ADD PROTECTION CIRCUIT ON A SWITCH BACK OF THE ENGINE
SWITCH ENGINE SHUT DOWN

FROM PREVIOUS CAR B/C:			
DRAWN	DATE	CHECKED	APPR.
MP	2015-01	n/a	CL
TECHNICAL REGULATION		DIMENSION	SCALE
10.4A		mm	n/a
NOTICE		REP: 069392	
MODEL:		Y3

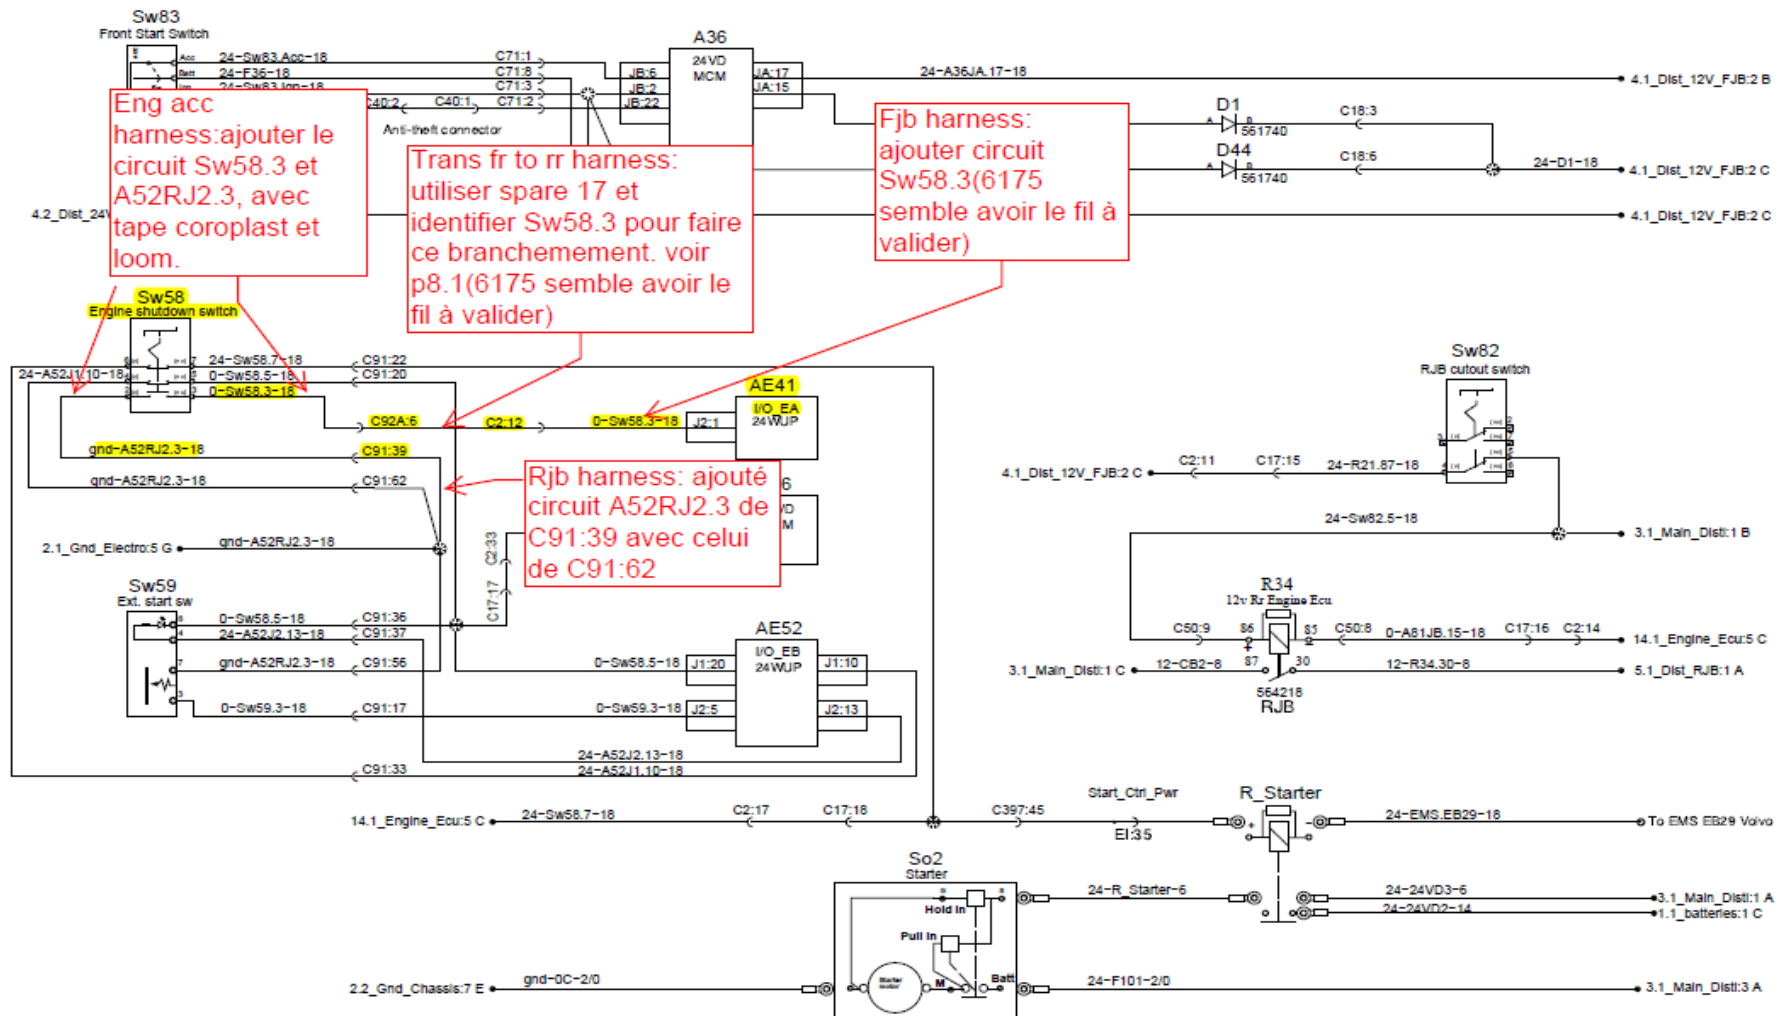
IN THE REAR JUNCTION BOX....

ADD WIRE BLACK 16 GA 562586 BETWEEN C91:62 AND C91:39 IDENTIFY THE CIRCUIT A52R J2.3

ADD BLACK 16 GA 562586 BETWEEN C91:39 AND THE SWITCH WIRE TO STOP ENGINE SW58.2 IDENTIFY CIRCUIT A52RJ2.3

PROTECTION TYPE COROPLAST AND LOOM ON THIS CIRCUIT

ADD 16 GA 562586 BETWEEN SWITCH BLACK WIRE CONNECTOR 6 C92A AND SW58-3

PROTECTION TYPE COROPLAST AND LOOM ON THIS CIRCUIT (CONNECTOR

USE WIRE SPARE 17 BETWEEN C92A-6 AND C2-12

IN THE FRONT JUNCTION BOX

ADD SW58.3 CIRCUIT BETWEEN C2-12 AND I O CONNECTOR J2 PIN 1 EA

Eng acc harness: ajouter le circuit Sw58.3 et A52RJ2.3, avec tape coroplast et loom.

Trans fr to rr harness utiliser spare 17 et identifier Sw58.3 pour ce branchement. p8.1(6175 semble avoir fil à valider)

Rjb harness circuit A52RJ2.3 C91:39 avec de C91:62

**SEE PHOTO
(SECTION 2)BELOW
FOR DETAIL**

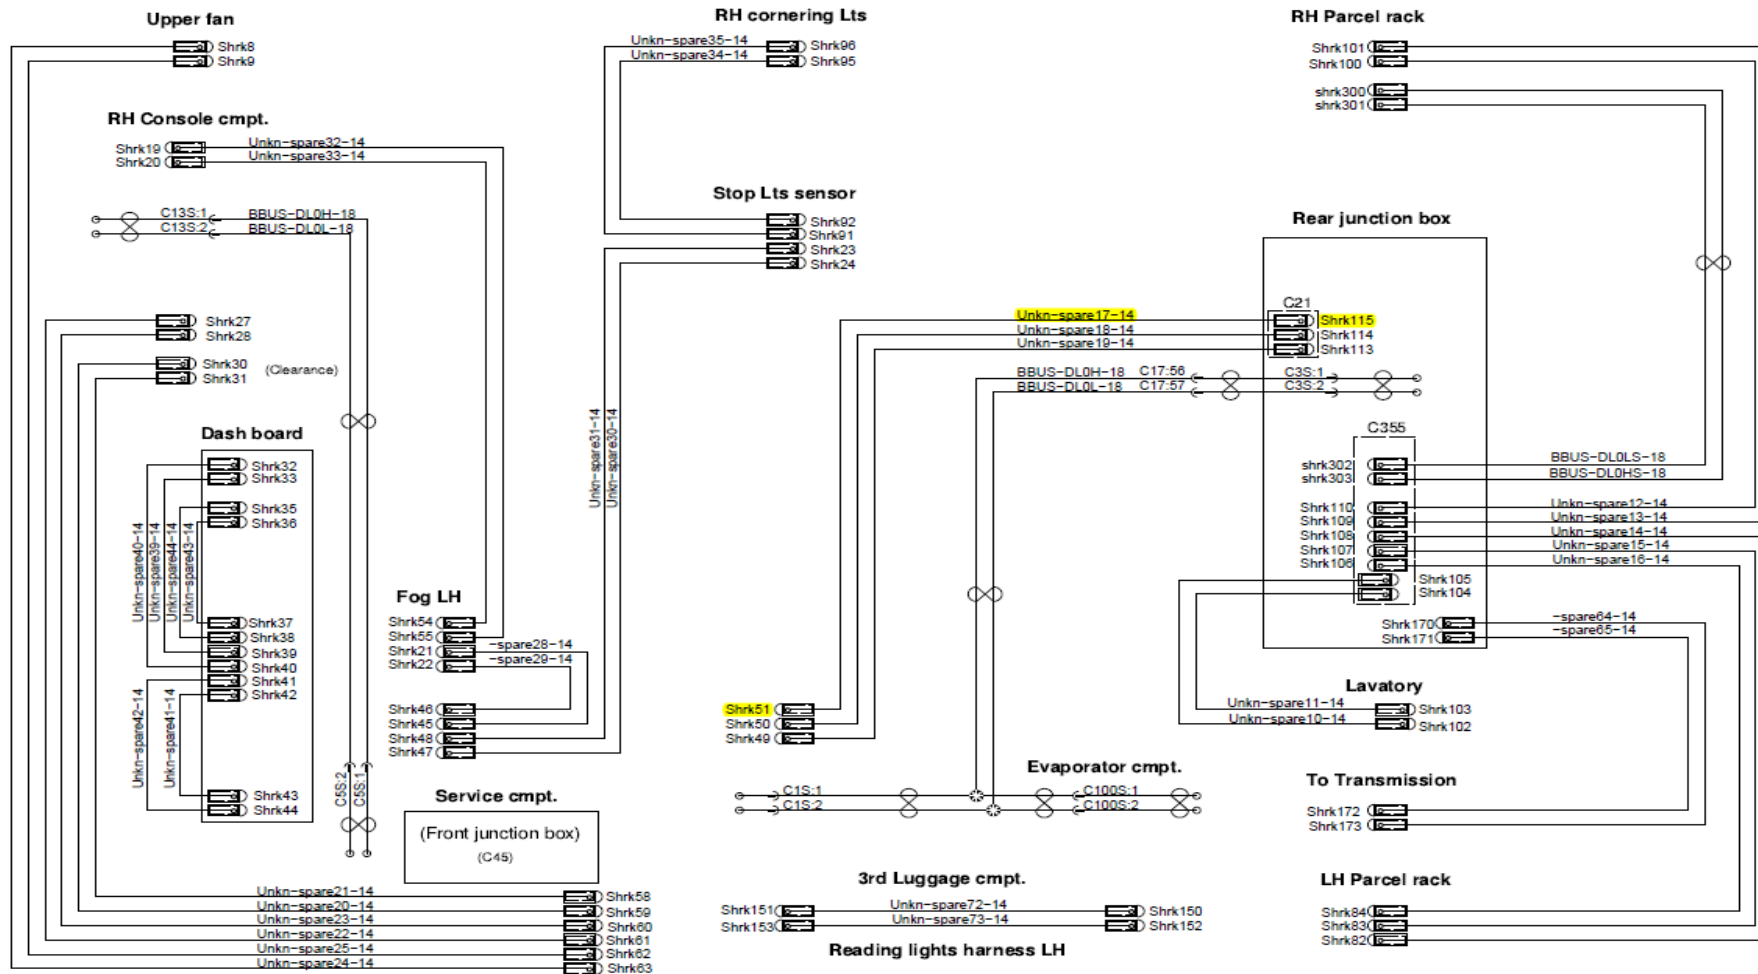
Spares wires
